**LANDMARK COMMISSION****August 3, 2026**

FILE NUMBER: COA-26-000329
LOCATION: 5714 Swiss Ave
STRUCTURE: Contributing
COUNCIL DISTRICT: 14

1. A Certificate of Appropriateness to construct a rear one-story covered porch.
2. A Certificate of Appropriateness to replace screens on front porch with all wood windows and doors.

PROPOSED WEST ELEVATION 04
SCALE: 1/4"= 1'-0"

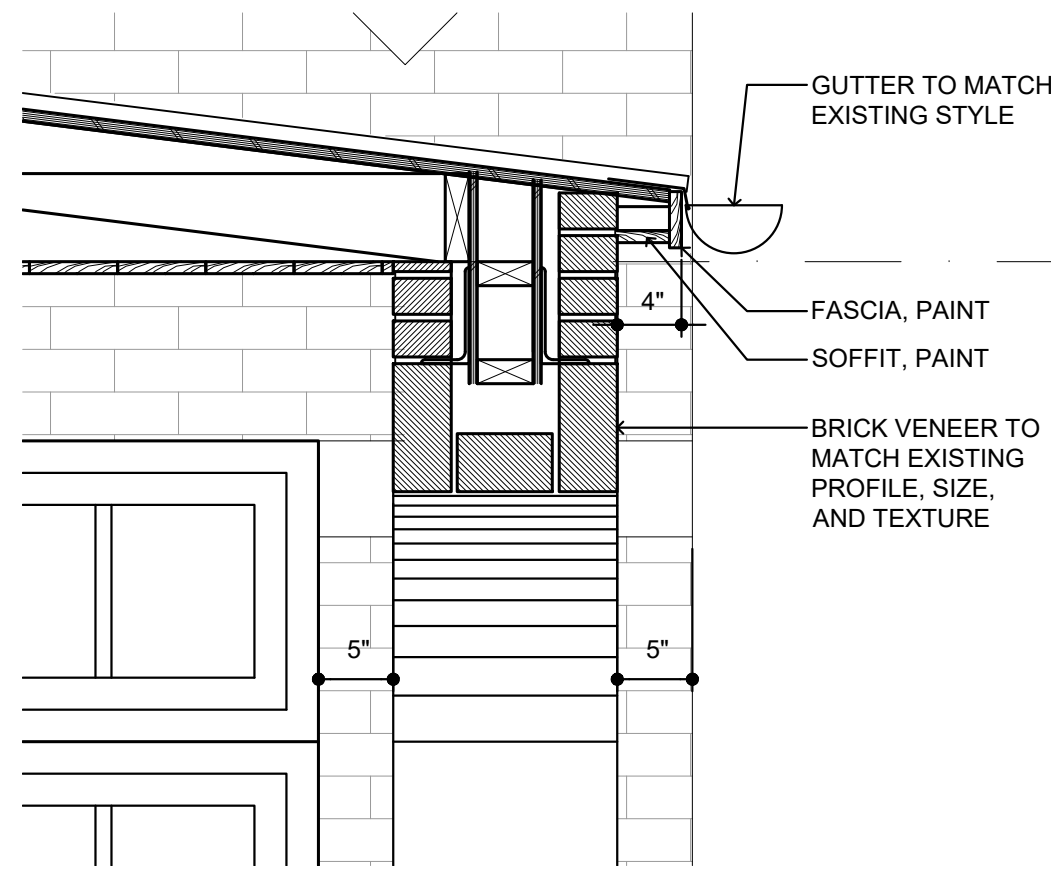
2. That the request for a Certificate of Appropriateness to replace screens on front porch with all wood windows and door be denied without prejudice with the finding of fact that per preservation criteria Sec. 51P-63.116(1)(K)(ii) a front entrance or porch may not be enclosed with any material, including iron bars, glass, or mesh screening. The proposed work is therefore not consistent with preservation criteria Sec. 51P-63.116(1)(K)(ii); does not meet City Code Section 4.501(g)(6)(C)(i) for contributing properties, and the Secretary of the Interior's Standards for Rehabilitation (Neighborhood/District).

PROPOSED PARTIAL SOUTH ELEVATION 03
SCALE: 1/4"= 1'-0"

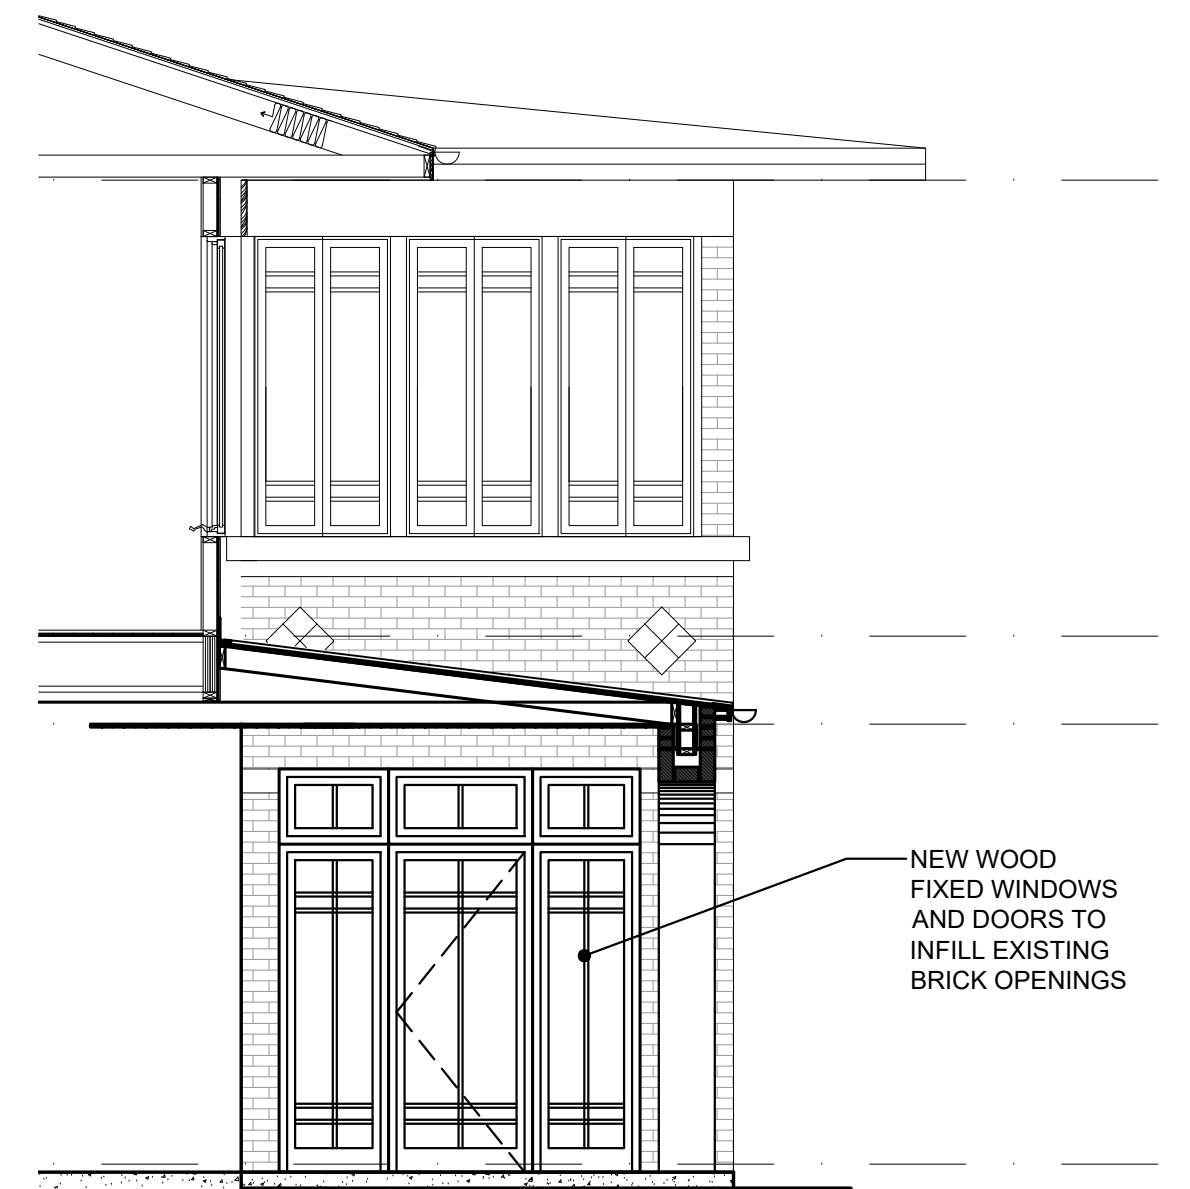
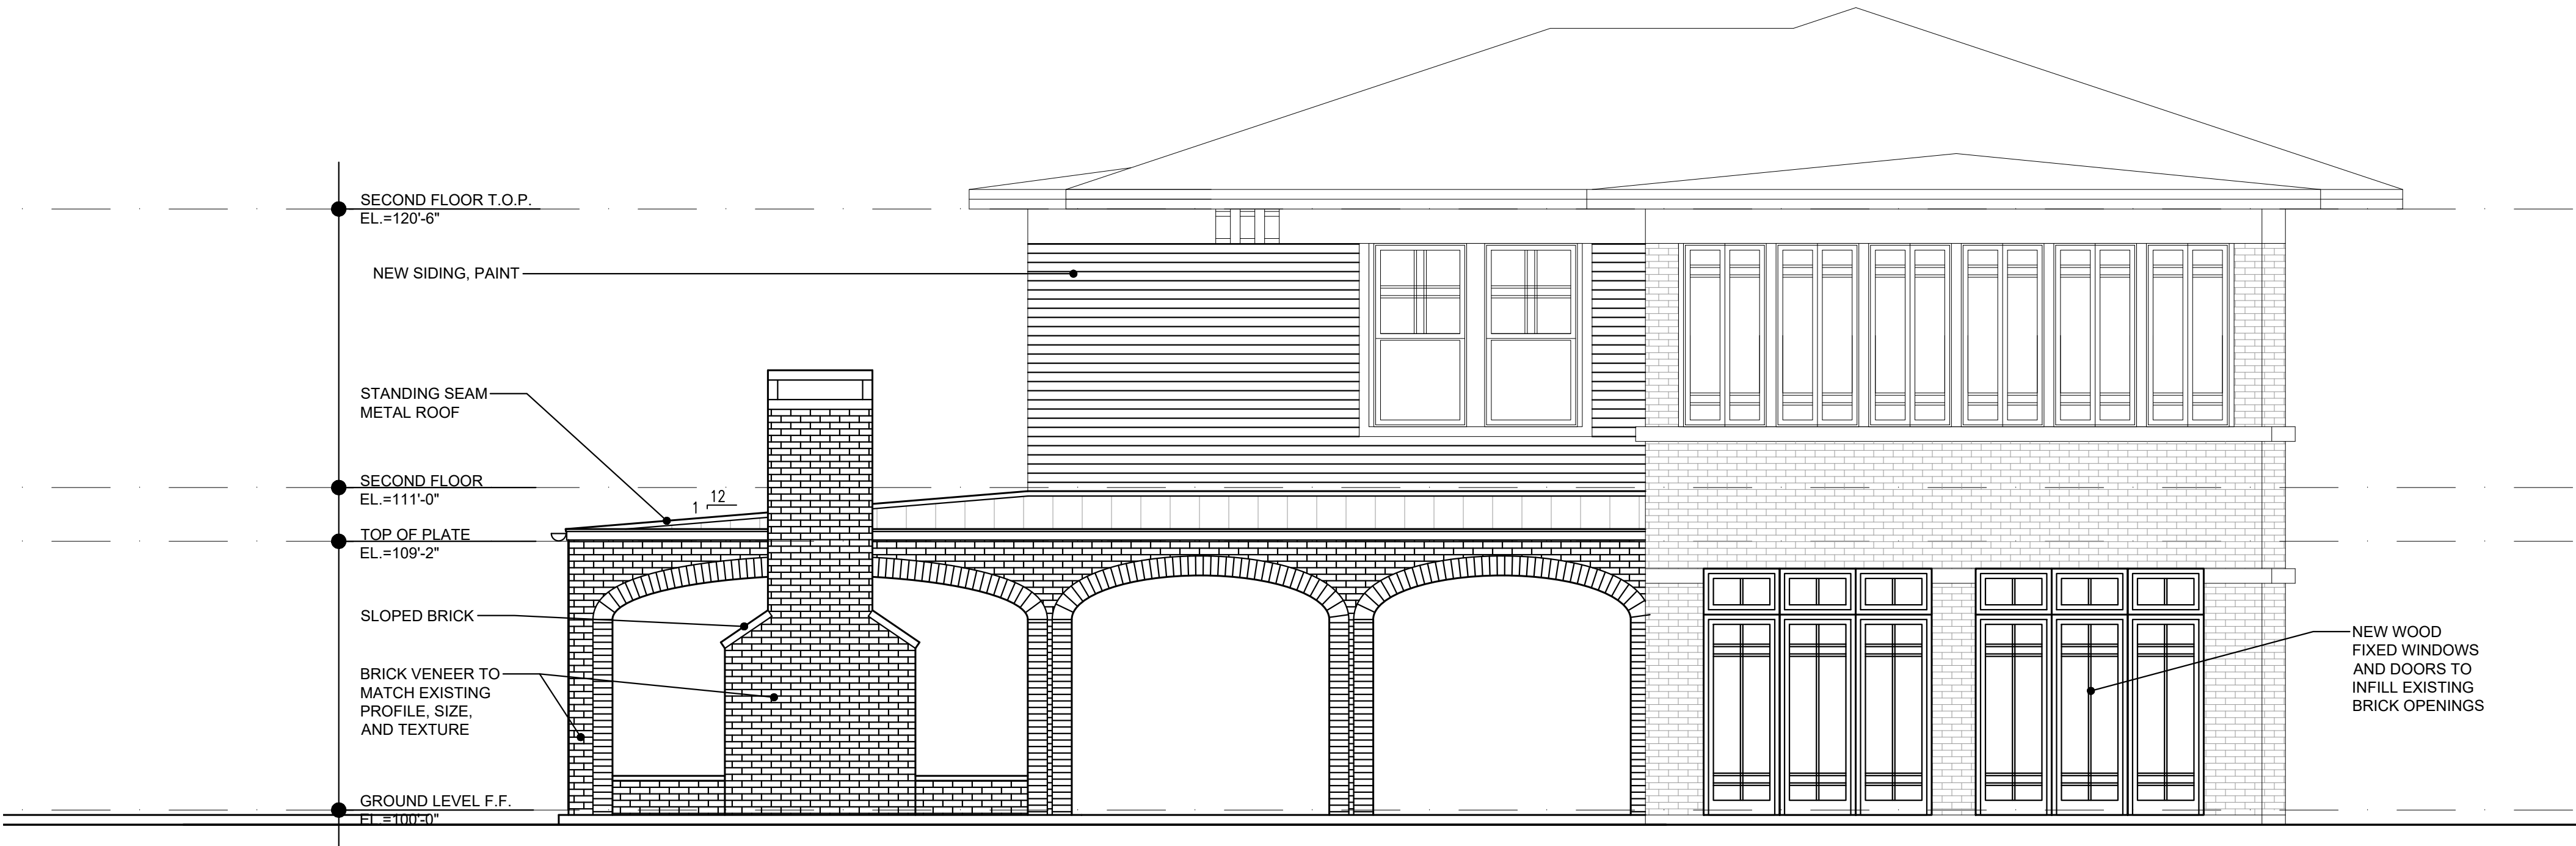
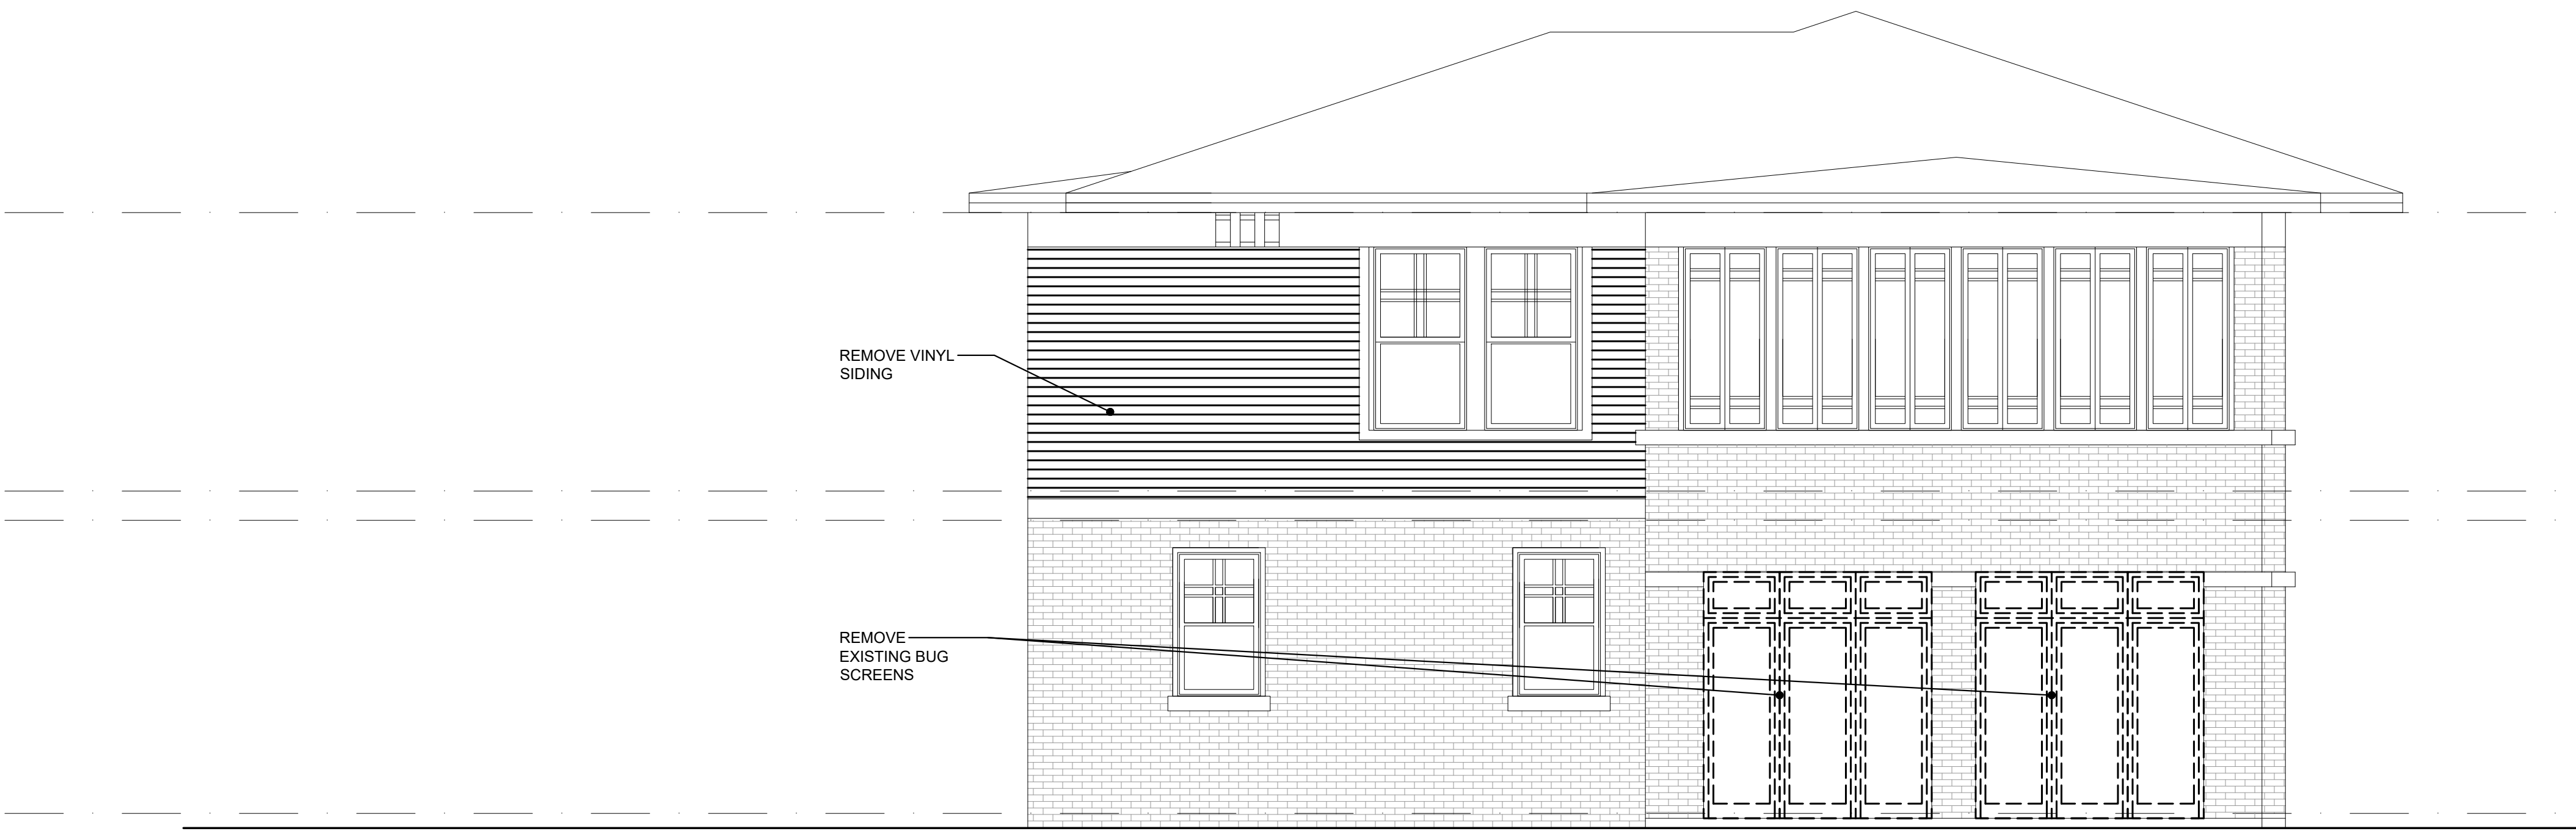
1. That the request for a Certificate of Appropriateness to construct a rear one-story covered porch be approved with the conditions that the delineation of the new porch addition is not flush with the main structure wall so that the overhang does not portude past existing main structure corner and that the replacement siding be wood and submitted to staff for approval. Implementation of the proposed condition would allow the work to be consistent with preservation criteria Sec. 51P-63.116(1)(B); meet City Code Section 4.501(g)(6)(C)(i) for contributing properties, and the Secretary of the Interior's Standards for Rehabilitation (Neighborhood/District).

1. That the request to construct a rear one-story covered porch be approved with the condition that the roof overhang be compatible with the style and scale of the main structure.
2. That the request to replace screens on front porch with all wood windows and door be approved.

roof overhang be compatible w/ style
to scale of Building
